Field Bulletin

- Boot Software Update
- SC66XX US PROM Units

Bulletin #:	FG00606
Bulletin Date:	May 11, 2006
Subject:	Boot Software Update
Affected Model(s):	SC66XX US

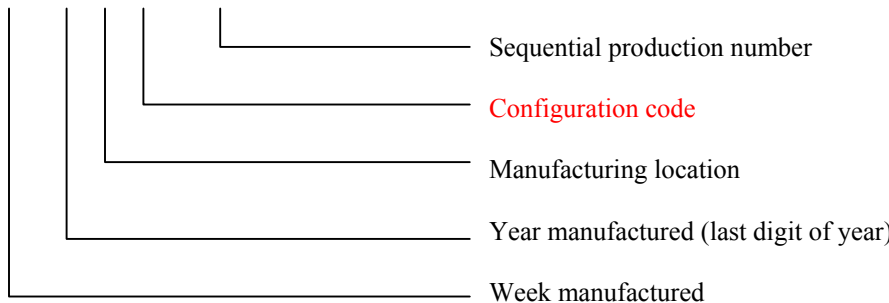
Summary:

SC66XX PROM units with older Boot Software (Bill Validator’s Internal Operating Software), Prior to version 1.06 will be required to have their Boot Software updated to the latest version (1.13) Before installing the new \$10 software.

Any SC66XX PROM US that has a Boot Software of V1.05 or earlier are required to update to the latest version of Boot Software (1.13). the older Boot Software is not compatible with the new \$10 PROM Software. Placing a PROM with the new \$10 software into a unit with V1.05 or older Boot Software will cause the unit to appear locked up and all three MMI LED’s will illuminated. Placing the previous version of software back in the unit will allow the unit to operate properly till the Boot Software can be updated into the unit.

SC66XX PROM units with Configuration Code 06 or lower indicates that the update is required. The serial number of the Acceptor contains the Configuration Code of the unit. The serial number of the Acceptor Module can be found on the sticker located on the bottom of the acceptor module (See below).
